Agenda
City of Charlottesville
Board of Architectural Review
Regular Meeting
June 22, 2022, 5:30 p.m.
Hybrid Meeting (In-person at CitySpace and virtual via Zoom)

Regular Meeting

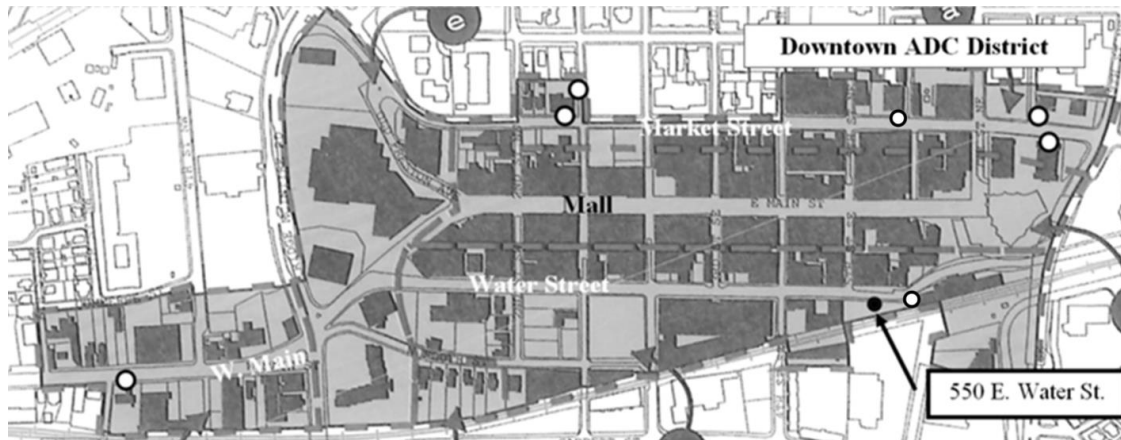
Staff finds that the proposed pole sign is appropriate for the Downtown ADC District; however, this finding assumes a single pole sign for this building. Within the building are ten condominiums, each with a separate Tax Map Parcel number and--either currently or potentially--separately owned. Staff is concerned that one pole sign here creates a precedent that might result in ten, separate pole signs in front of this building. Staff has requested a determination from the Zoning Administrator and will present that prior to the June 22 meeting. Should those broader questions related to the City's sign ordinance not be resolved--separate from the design review of this one sign--staff recommends this be deferred to the July 19, 2022 BAR meeting.

Staff comment: Height of proposed sign is 4.33 feet. The building is not set back *deeply* on the lot; however, the building's façade is not built to the sidewalk and at this location the wall is approximately 16 feet from the sidewalk (approximately 20 feet from the curb) with the proposed pole sign 1 foot from the sidewalks (approximately 5 feet from the curb).

Deferral: I move to defer this matter to the July 2022 BAR meeting, with the instruction that staff provide clarifications on questions related to the sign ordinance, including the potential for precedent, and provide an inventory of pole signs within the Downtown ADC District, particularly those reviewed by the BAR under City Code Sec. 34-1041.

REPLACE (10) WINDOWS IN BUILDING ADDITION
MATCH 6/6 WINDOWS ON UPPER FLOORS

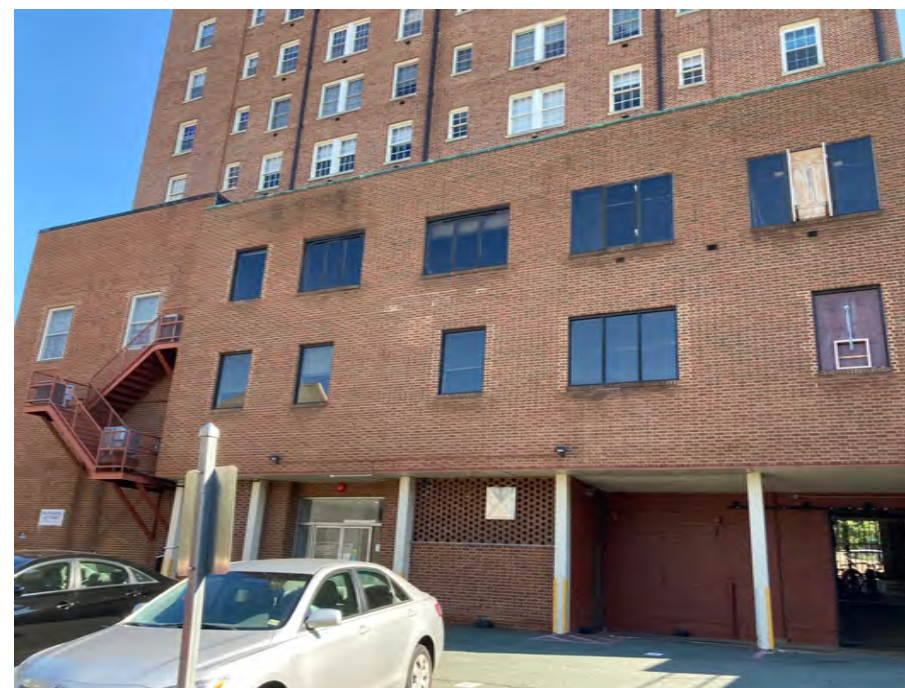
CoA to replace non-historic windows on second and third floors of south addition and extend the rear fire escape to ground and install fire escape door at third floor. (Installing the door and the lower section of the fire escape will replace previously removed elements.)

Replacement windows will be white aluminum clad, double hung Marvin Ultimate windows. Existing brick sills will be retained.

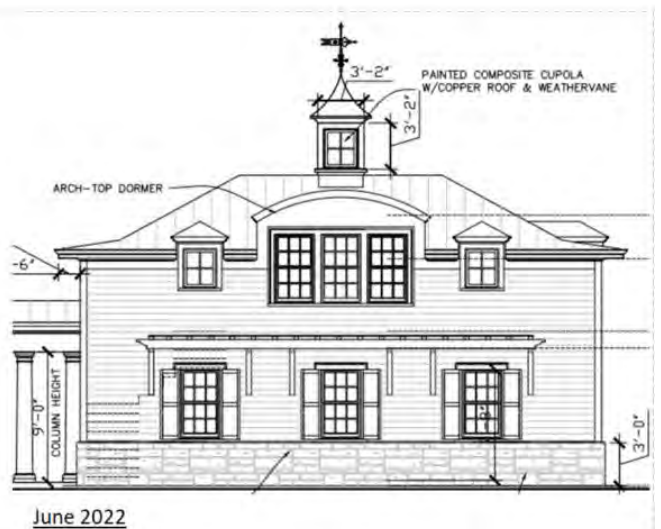
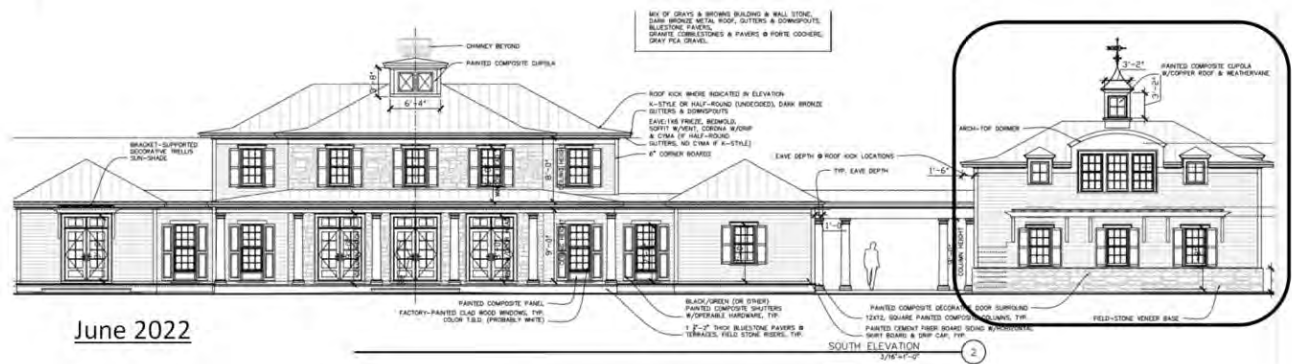
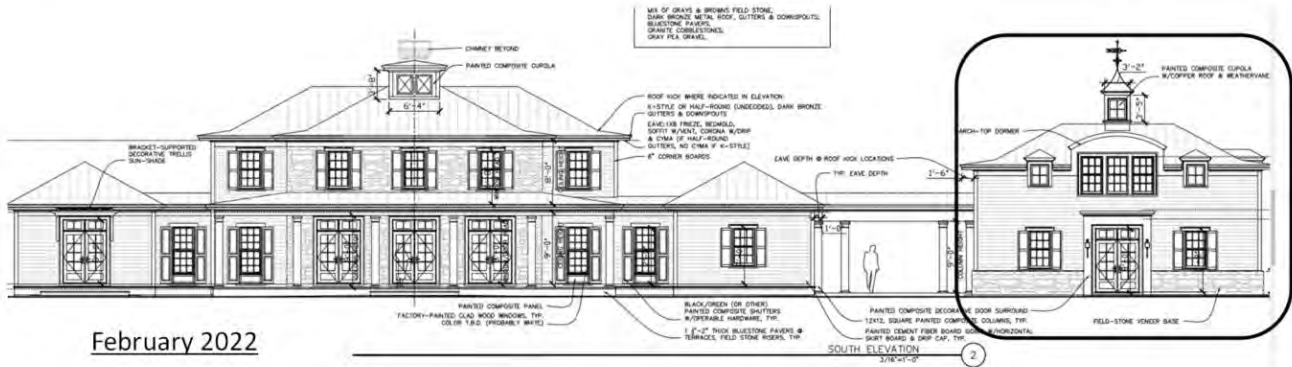
Staff Comment: The Design Guidelines suggest that building detail and ornamentation relate to the surrounding context. Staff finds the proposed style and details similar to those found in the subarea; however, the building reads as a contemporary structure. During the preliminary discussion, the BAR expressed concern that some elements—for ex., the garage cupola—are more elaborate than those found nearby. Staff agrees the proposed house has a greater degree of elaboration than its neighbors; however, the proposed design and materials are not incompatible with the subarea.

Regarding the site, staff is concerned that a substantial amount of the front yard is consumed by the driveway and parking area. Chapter II of the Design Guidelines (Site Design & Elements) recommend placing parking in the rear:

Staff recommends a condition of approval requiring that engaged columns be square

Front Setback

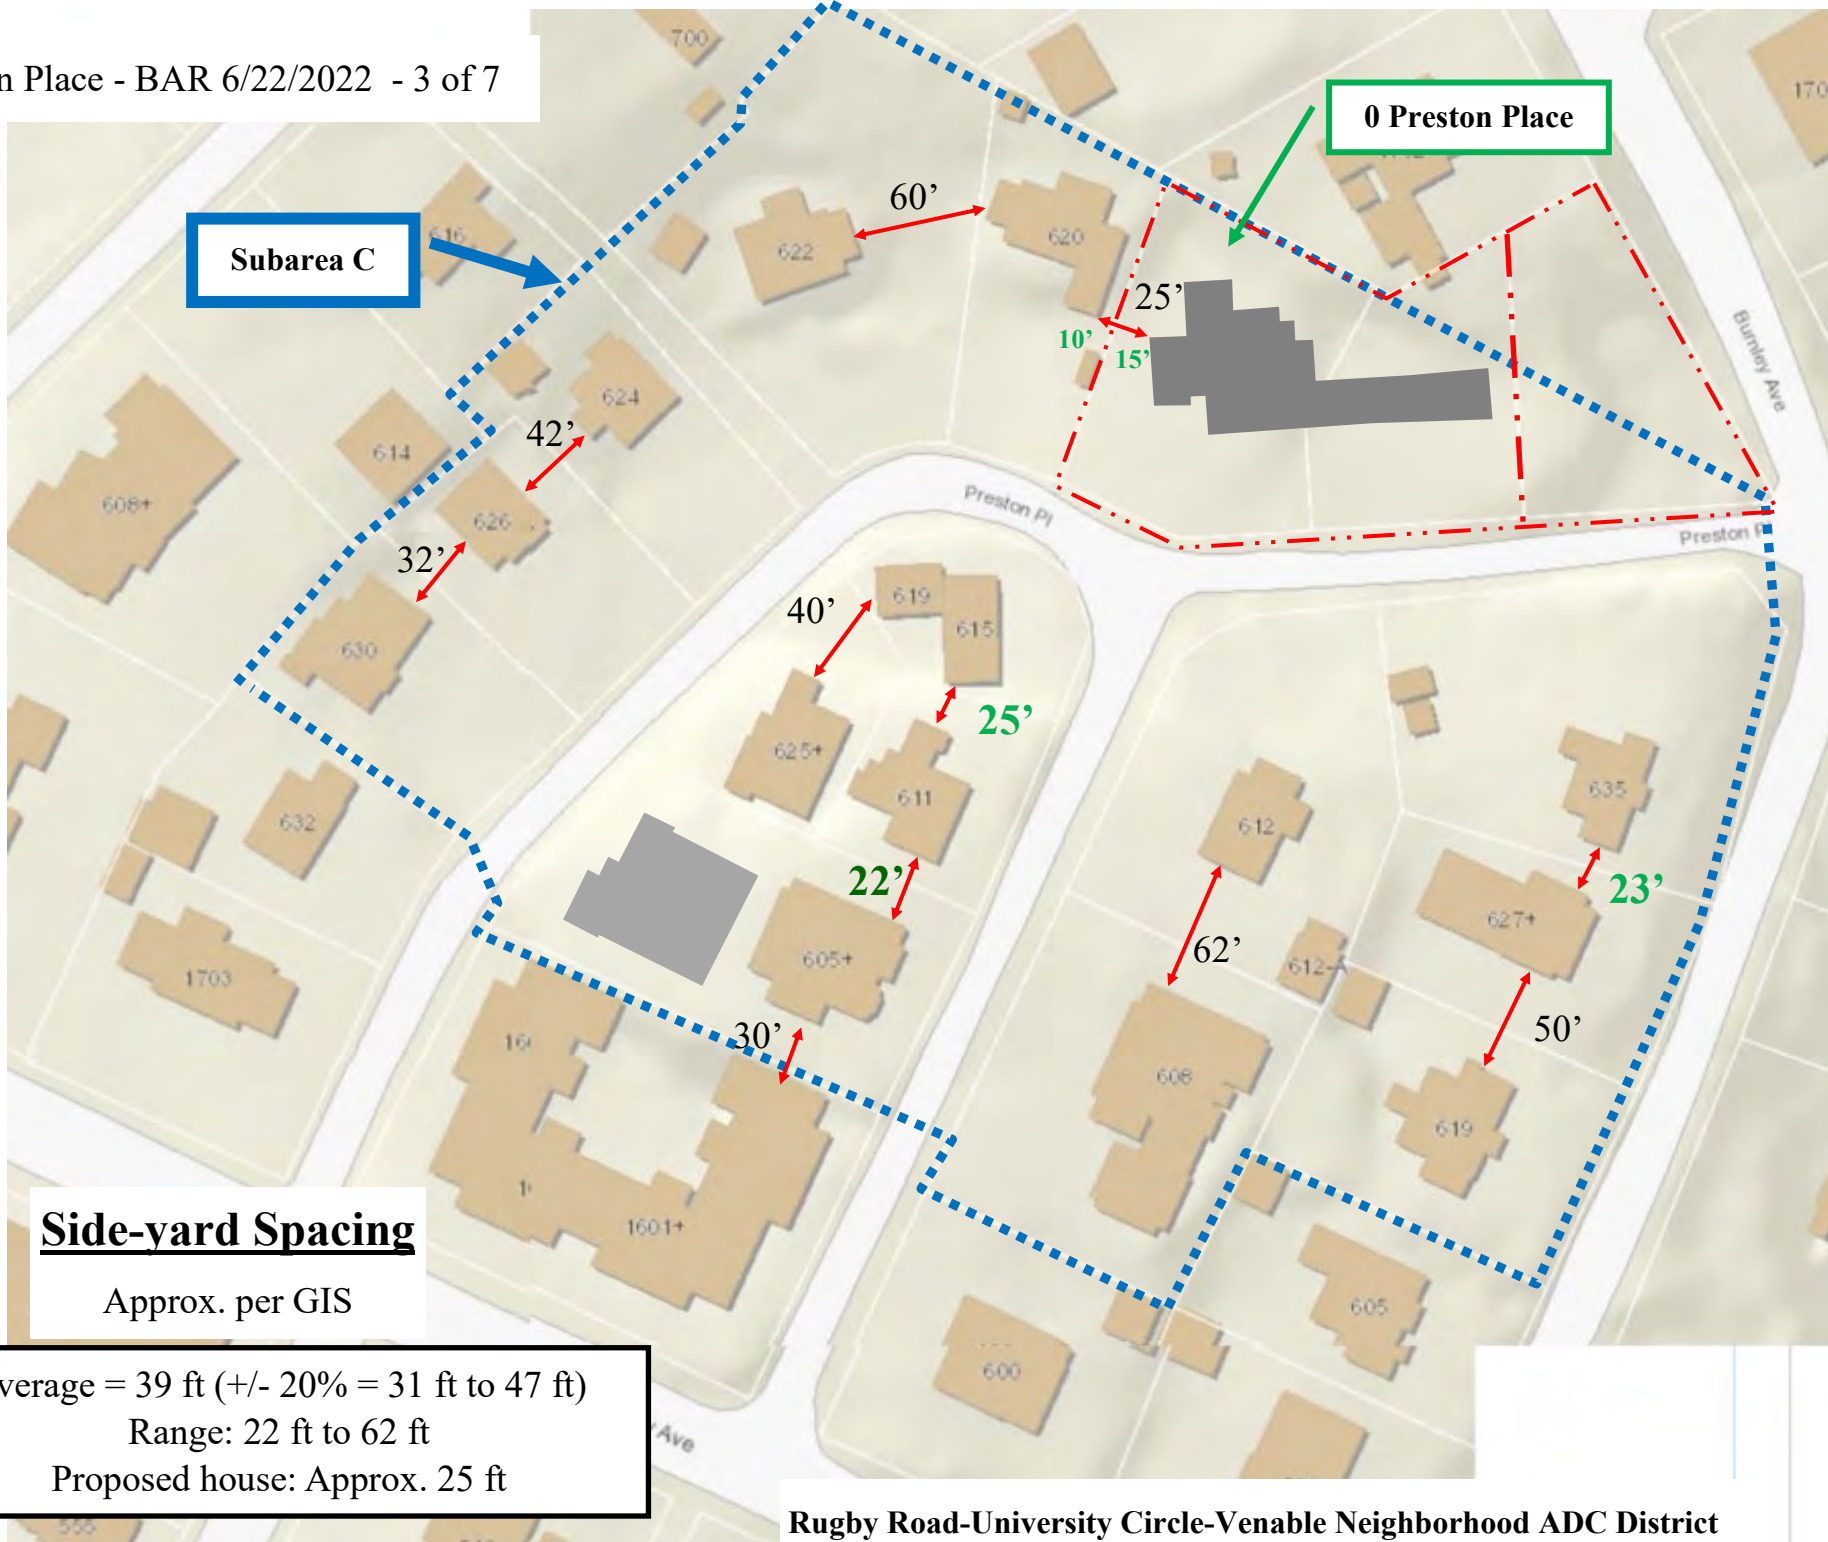
Average = 51 ft (+/- 20% 41 ft to 61 ft)
Range: 20 ft to 80 ft
Proposed house: Approx. 45 ft

Side-yard Spacing

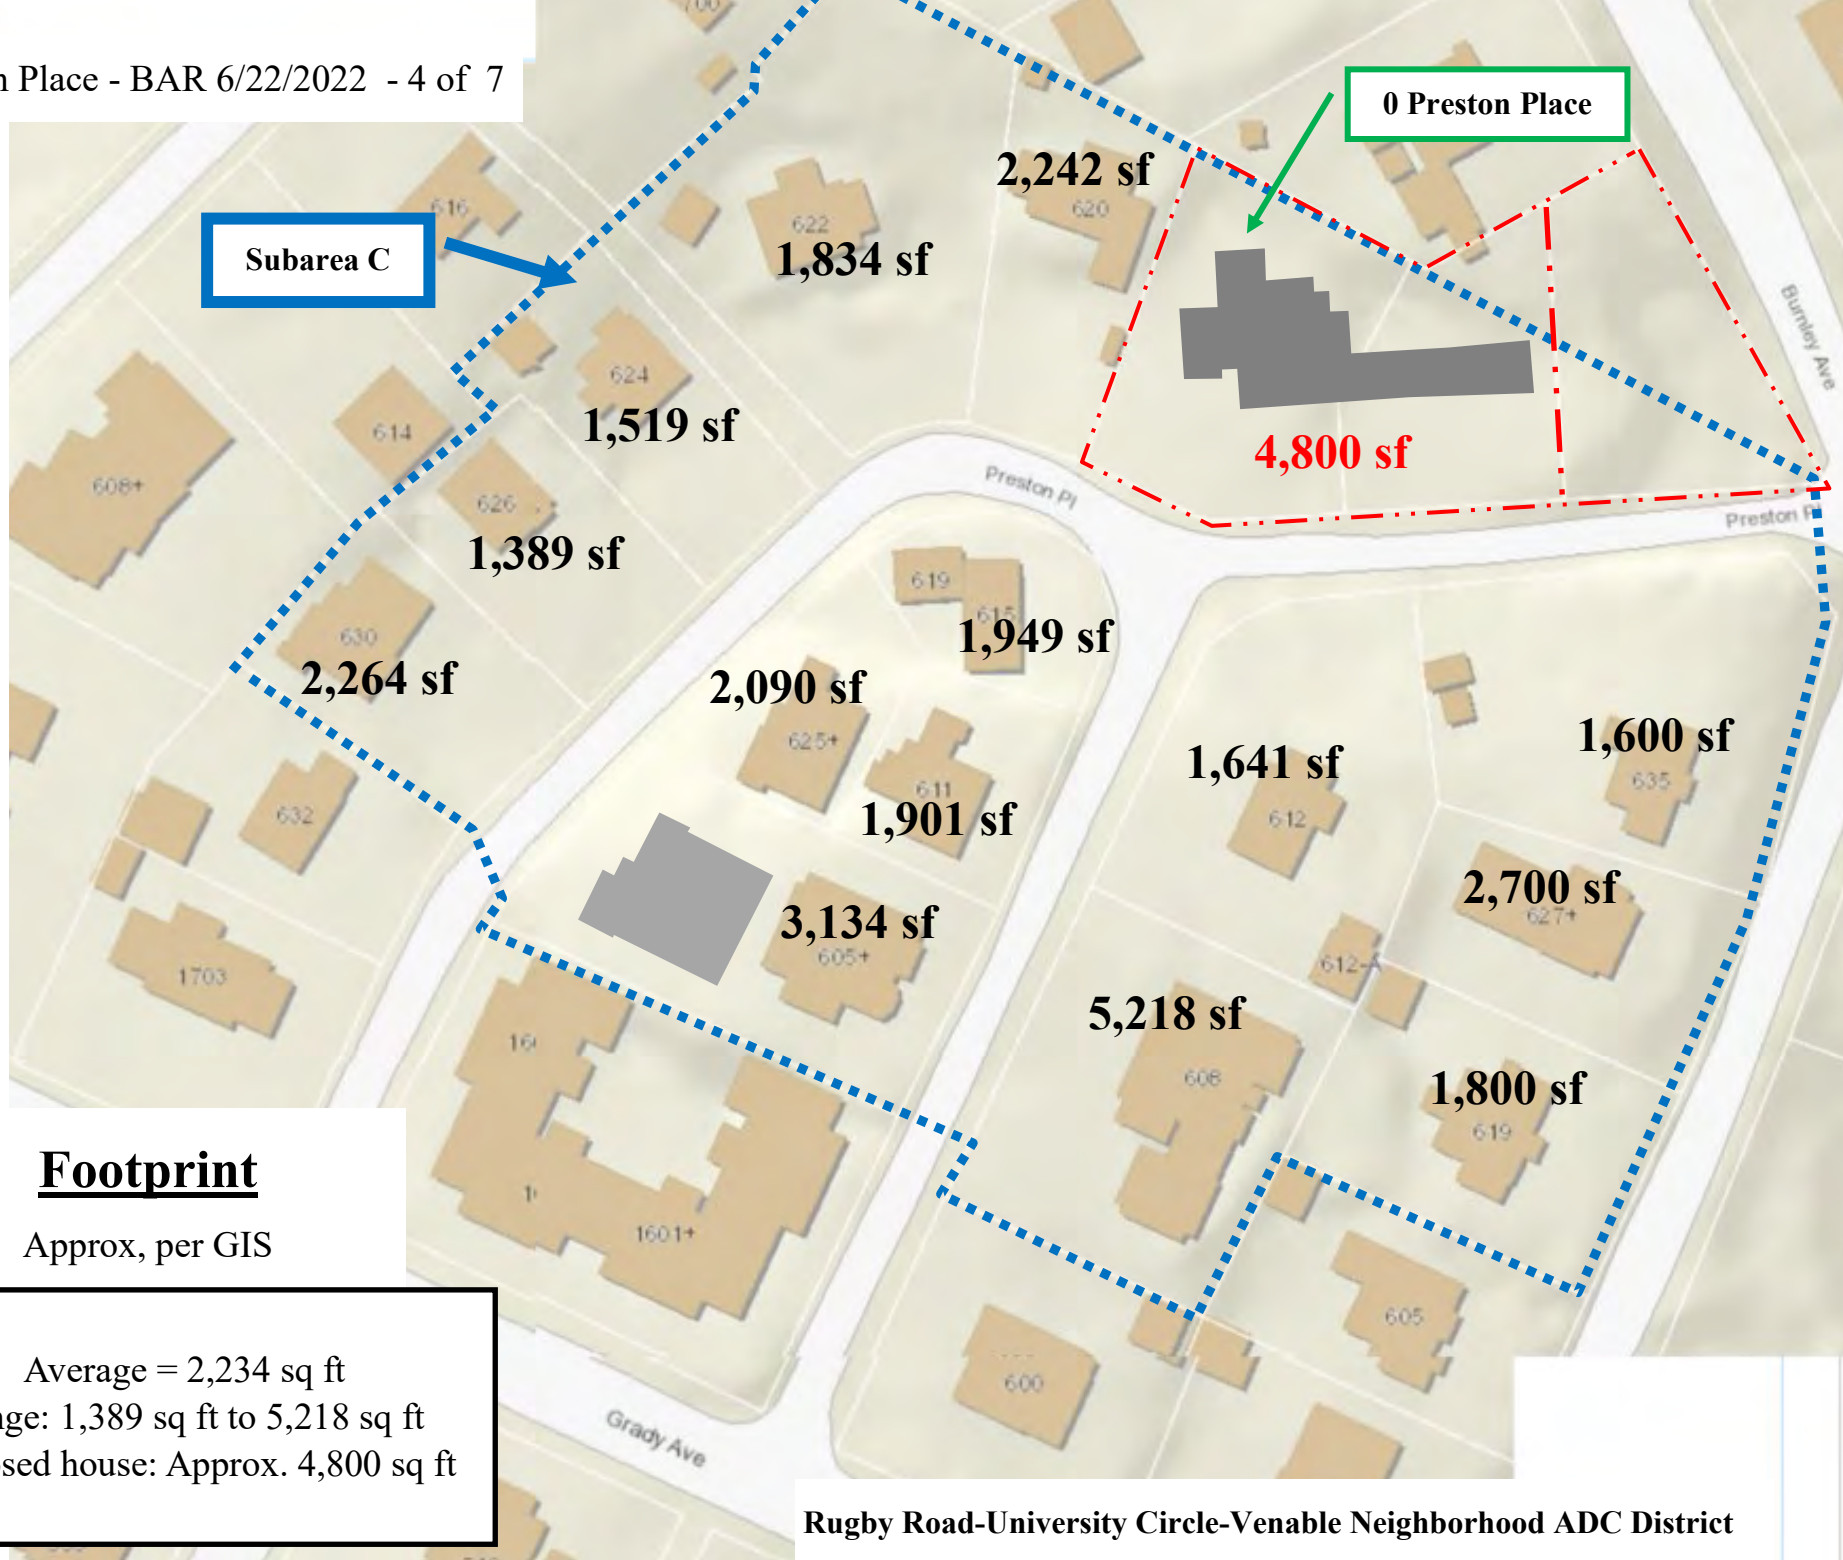
Average = 39 ft (+/- 20% = 31 ft to 47 ft)
 Range: 22 ft to 62 ft
 Proposed house: Approx. 25 ft
